**COMMON COUNCIL
MEETING NOTICE AND AGENDA
Monday, October 2, 2023
6:30 PM**

Project Name: WVRC Conditional Use, Rezoning, and Site & Building Plans

WVRC comment response letter

IMPROVEMENT PLANS FOR WVRC EMERGENCY VET CITY OF PEWAUKEE, WI

C101

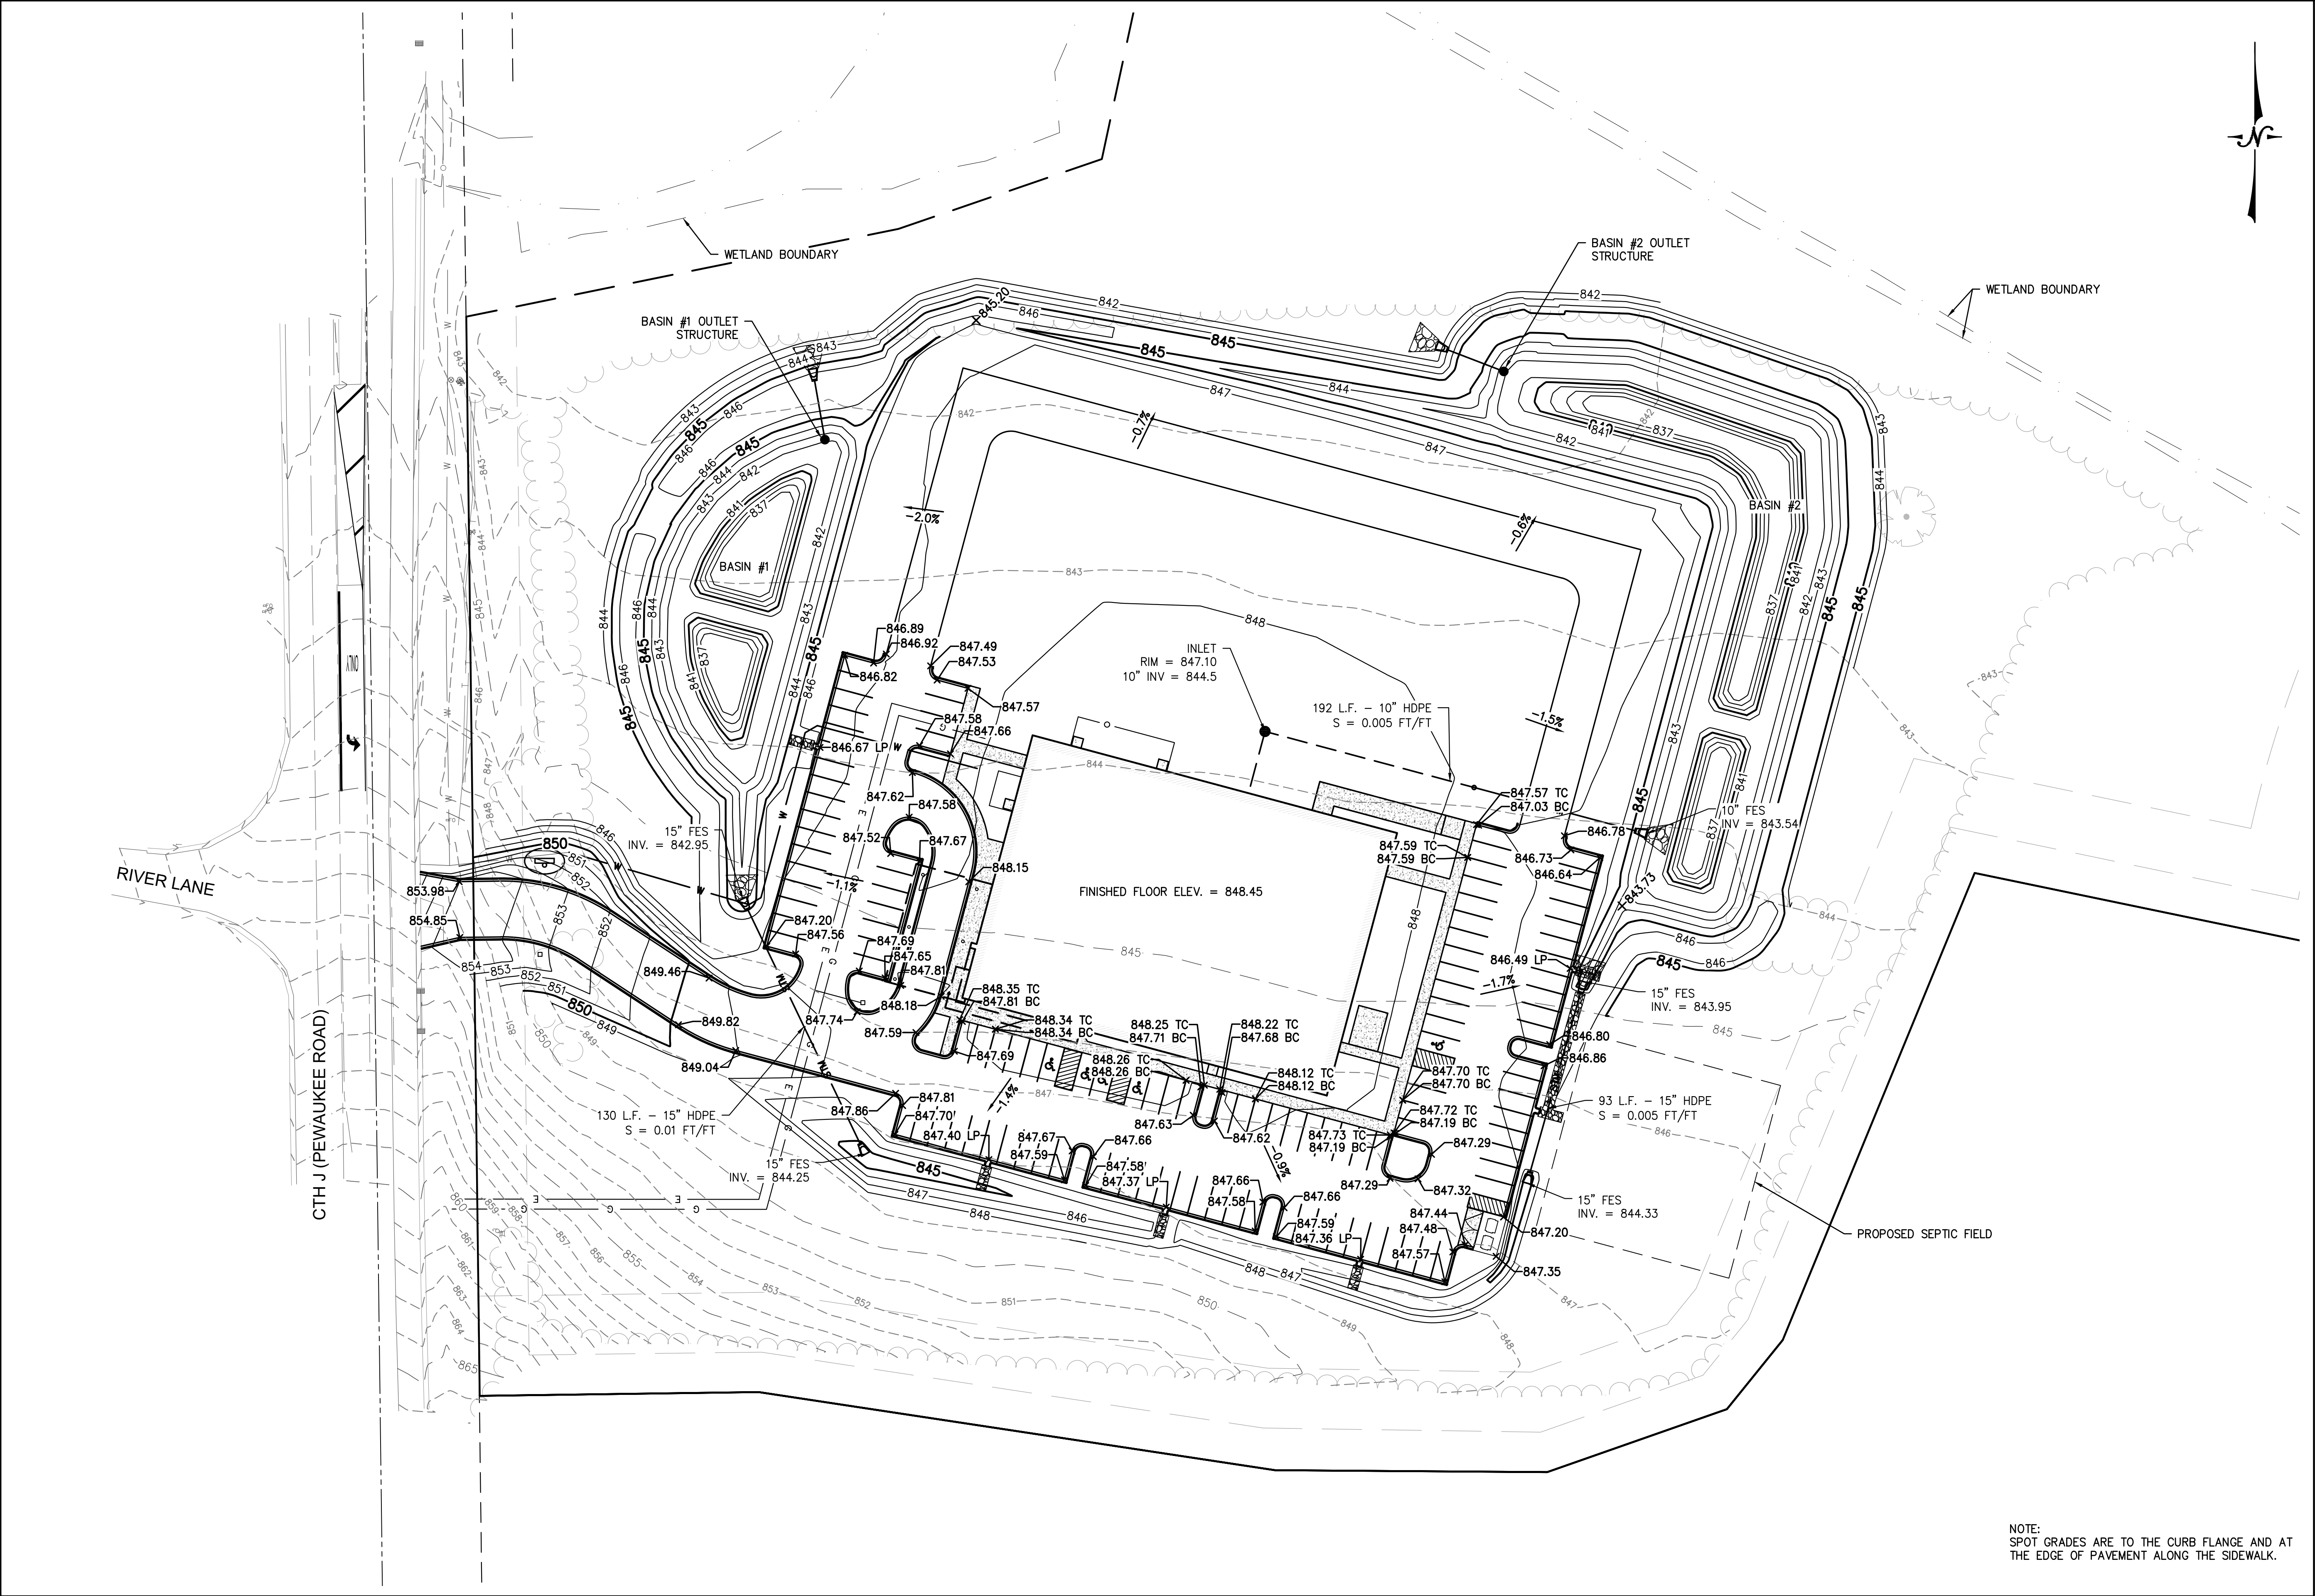
1. The proposed entrance exceeds the maximum allowable width. Proposed commercial or industrial entrances shall not exceed 30 feet at the right-of-way and 36 feet at the roadway. **Dimensions have been added to the plan. Driveway entrance has been changed and is now 36' wide. Grading has been updated to reflect these changes.**

2. The site plan shows the future outline for this site to expand the proposed building. If this expansion were to take place, the proposed storm sewer would be below the building. Provide a note describing changes to the storm sewer which would be required if the future building expansion occurs. **Notes added to site plan sheet detailing the removal of storm sewer under the future addition.**

3. A concrete curb cut will be required along the east curb line near the proposed septic field (See Sheet C102 comments). **Low point and corresponding curb cut has been added to the plans.**

4. Identify that improvements within the CTH J right-of-way will be included in this project. **A note has been added to see sheet C404 for all CTH J improvements.**

5. Provide a wetland delineation report for mapped wetlands identified on the parcel. **Wetland delineation map included in submittal.**
6. Provide a table on this sheet showing the impervious area, pervious area, and ratio for the existing, proposed, and future conditions. **Table has been added to the site plan.**

7. The proposed site plan includes a septic field in the design. The City anticipates construction within the Sherwood Forest Subdivision, which will likely include a sanitary sewer extension within Kings Drive. This parcel abuts Kings Drive and would likely have a special assessment levied for the roadway and utility construction. Additionally, the parcel would be required to connect to the City's sanitary sewer system within 15 years following construction completion. **Septic field to be designed by others. Future sanitary service will be considered during design of septic field system.**

SHEET NO.
C102

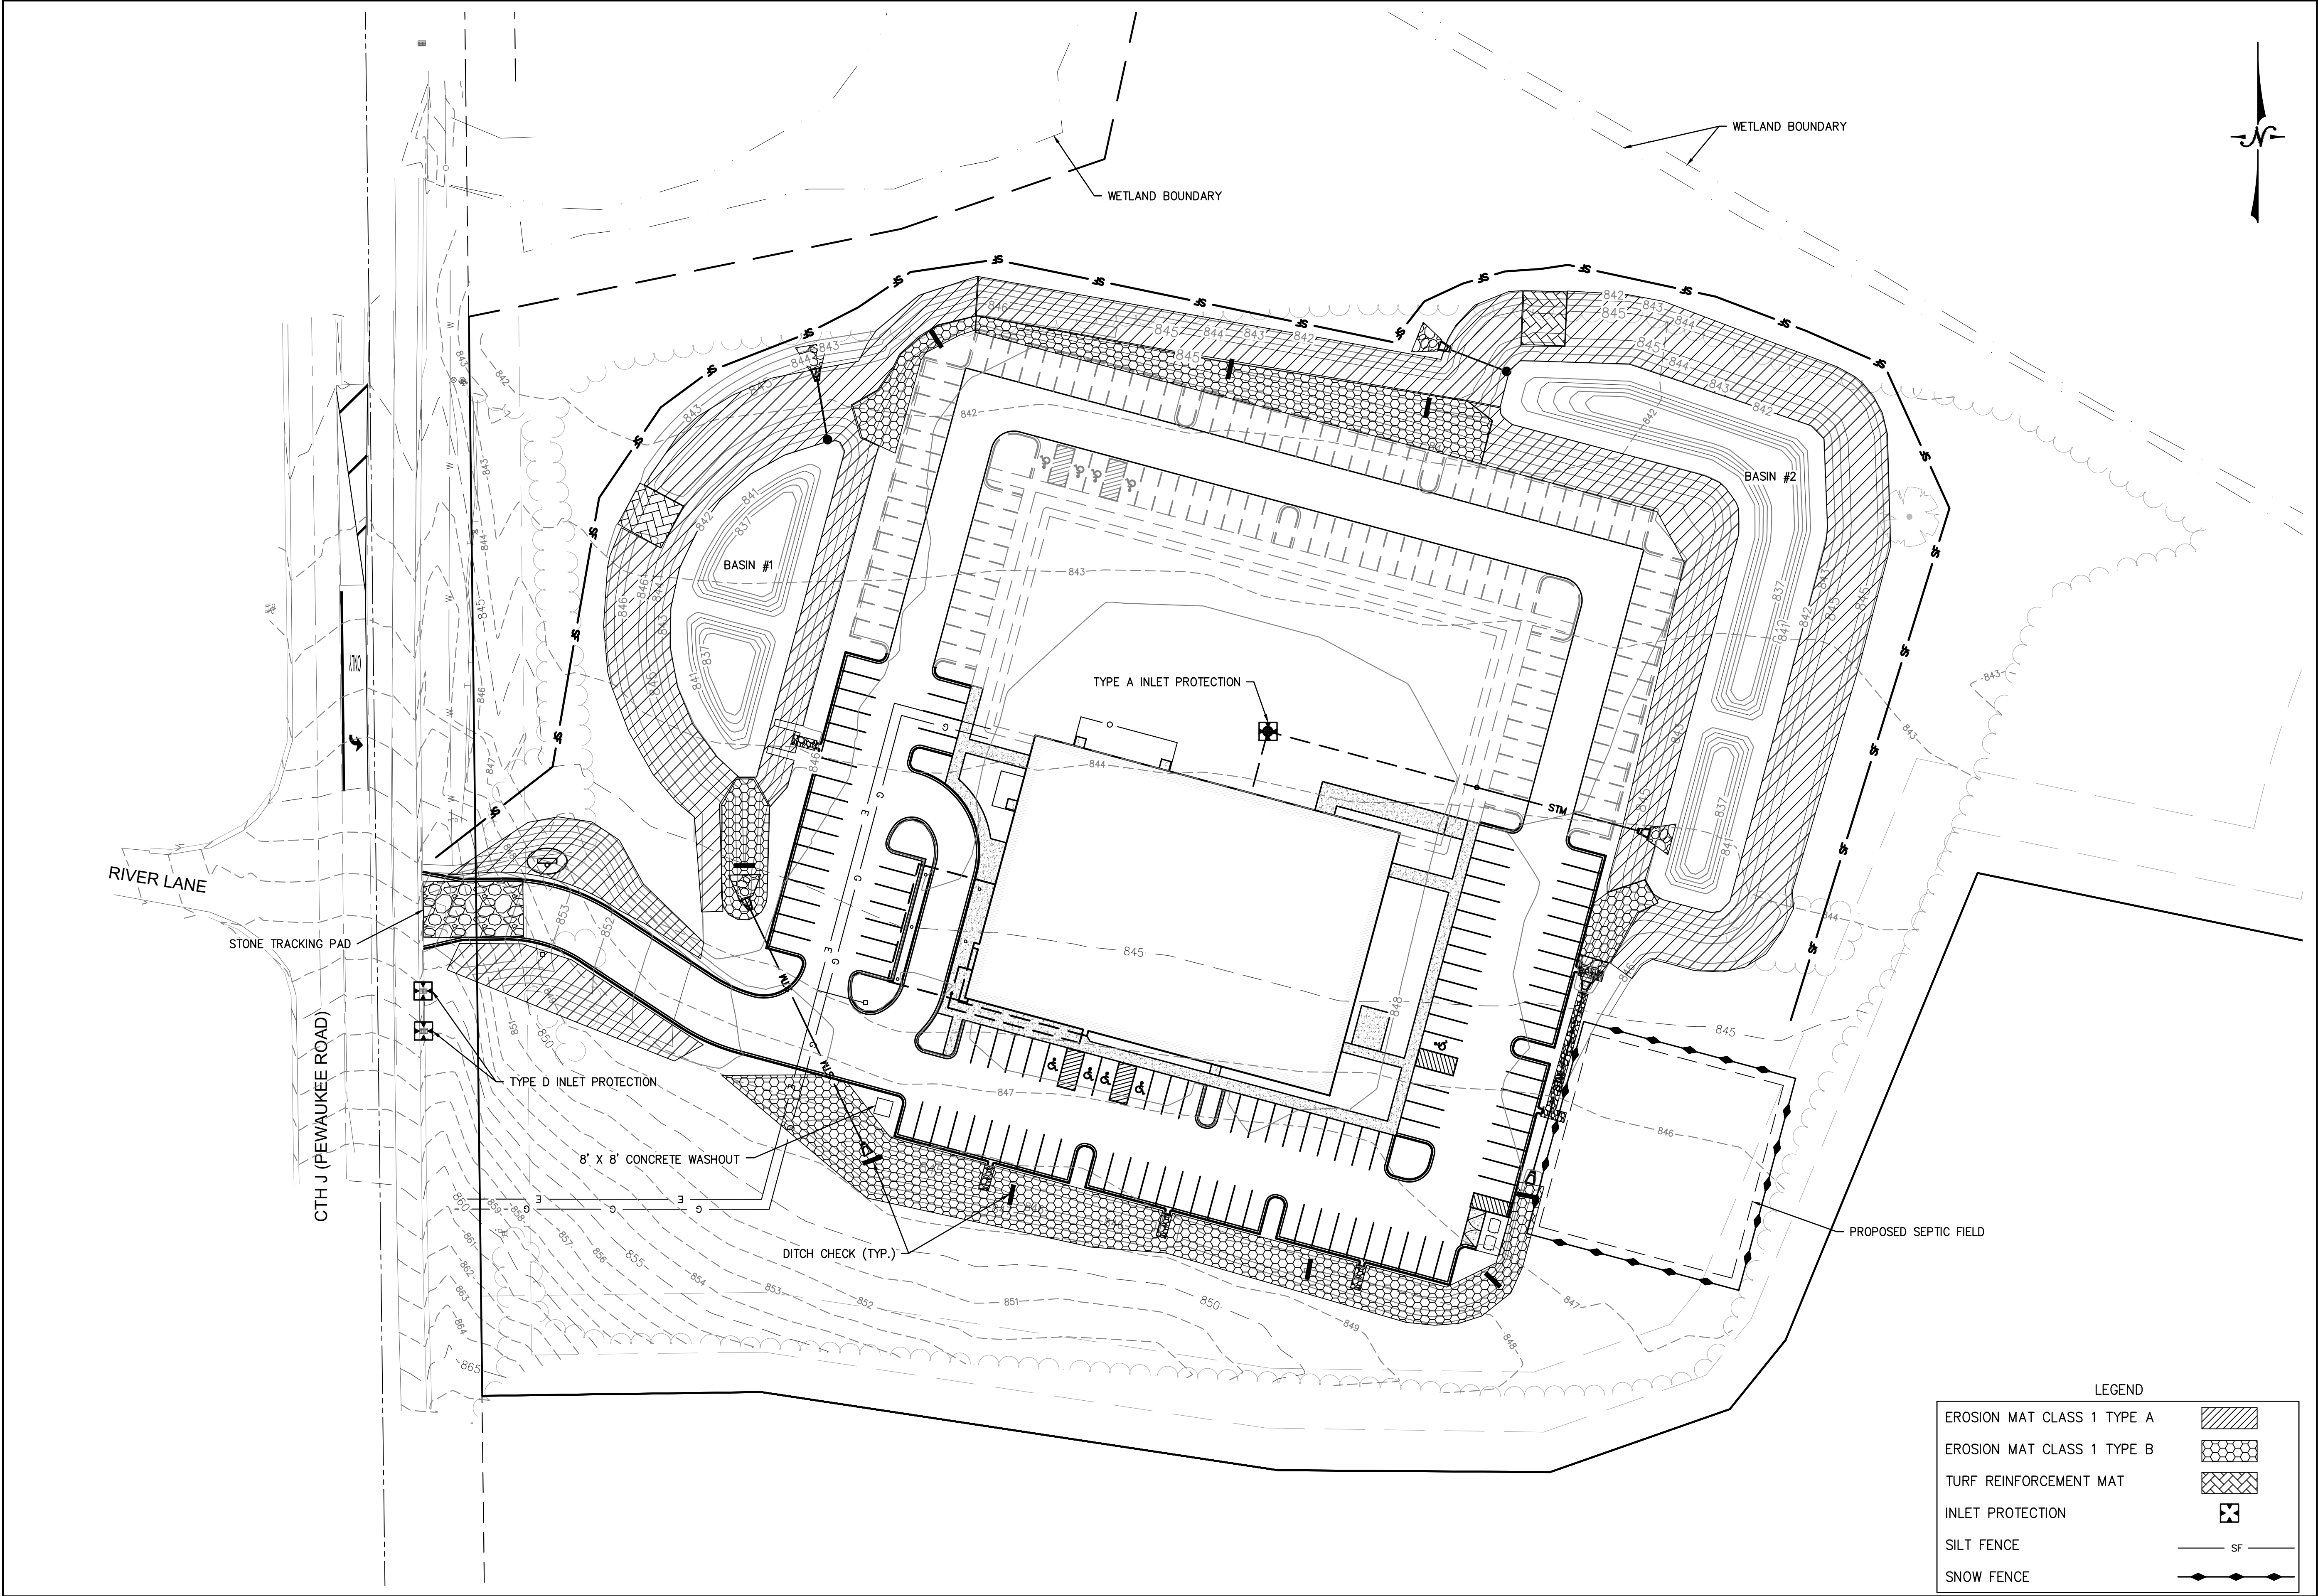
Sheet C102 – Grading Plan:
